Urgent Field Safety Notice

SBN-RDS-CoreLab-2021-003

Iron Gen.2: throughput dependent signal drifts on cobas c 311, cobas c 501/502 and COBAS INTEGRA® 400 plus

Attachment 1:

3.1.1. **cobas c** 311/501:

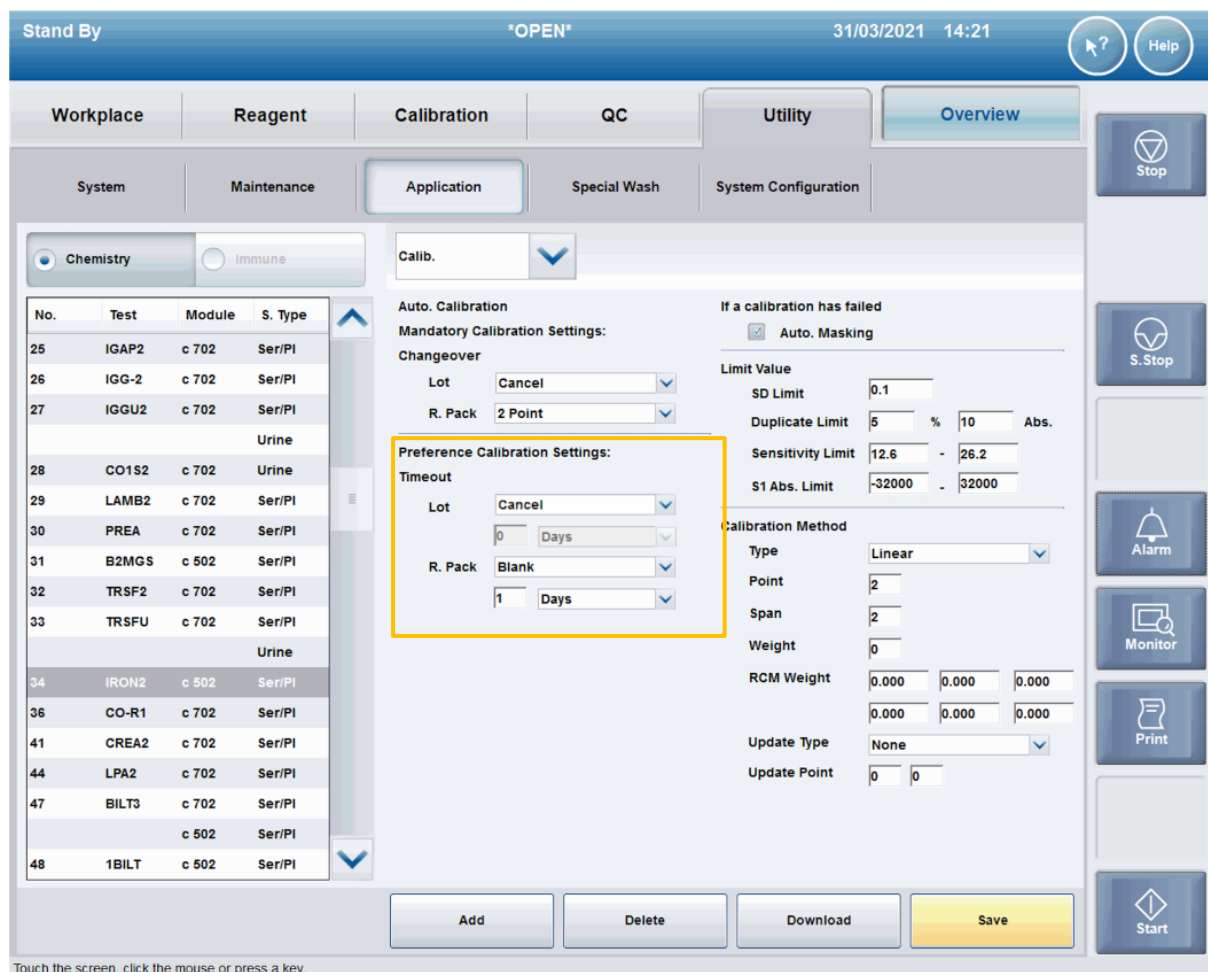
Modules running < 50 IRON2 determinations per day out of one **cobas c** pack need to perform a blank calibration with the zero calibrator using deionized water, which can be set on the analyzer by changing the [cassette/R. Pack](#) calibration "Timeout" to "blank" and a "timeout" to "1 day" as follows:

Utility >> Application >> Calib. >> Auto Calibration >> [Cassette](#) Blank 1 Day >> Save

According to the method sheets of IRON2, the calibration recommendation for cassette calibration Timeout is a 2-point calibration every 7 days. After Changing the cassette calibration “Timeout” to “Blank” every day, customers are still required to perform a 2-Point calibration manually after 7 days if the cassette is on board for at least 7 days.

The changed calibration pattern applies only to cassettes loaded after changing the setting.

3.1.2. cobas c 502:

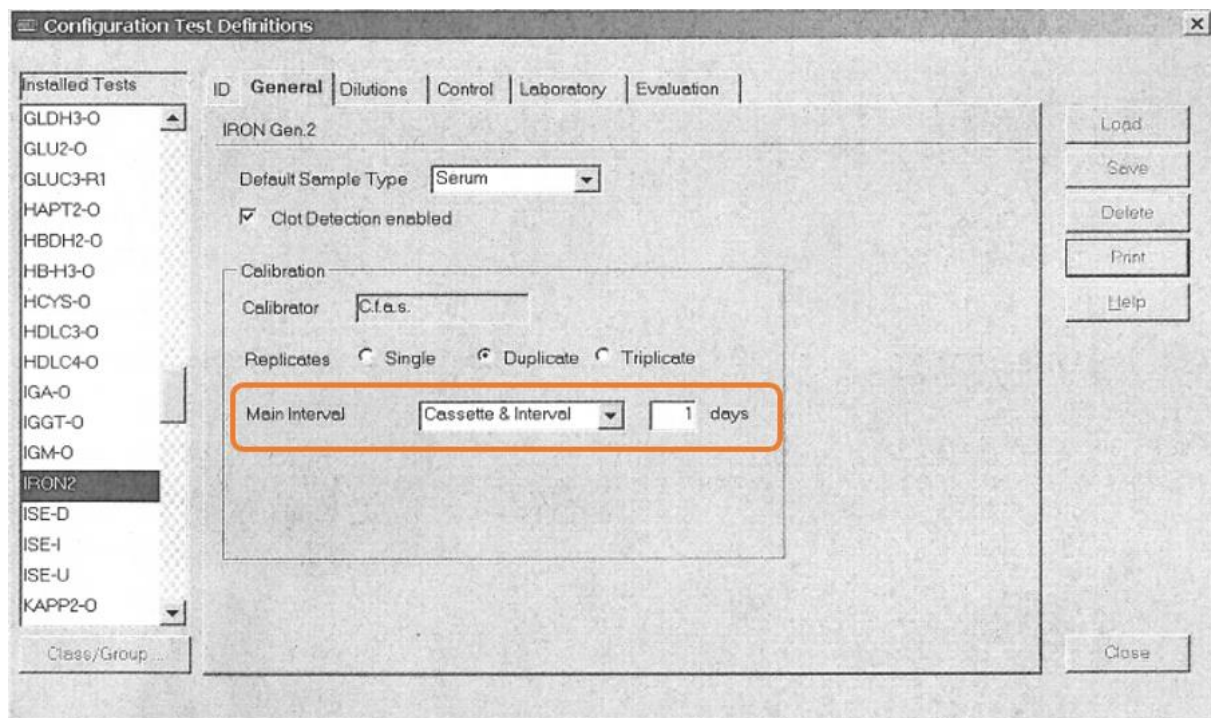
Utility >> Application >> Calib. >> Preference Calibration Settings >> [R. Pack Blank 1 Days](#) >> Save

According to the method sheets of IRON2, the calibration recommendation for cassette calibration Timeout is a 2-point calibration every 7 days. After Changing the cassette calibration “Timeout” to “Blank” every day, customers are still required to perform a 2-Point calibration manually after 7 days if the cassette is on board for at least 7 days.

The changed calibration pattern applies only to R. Packs loaded after changing the setting.
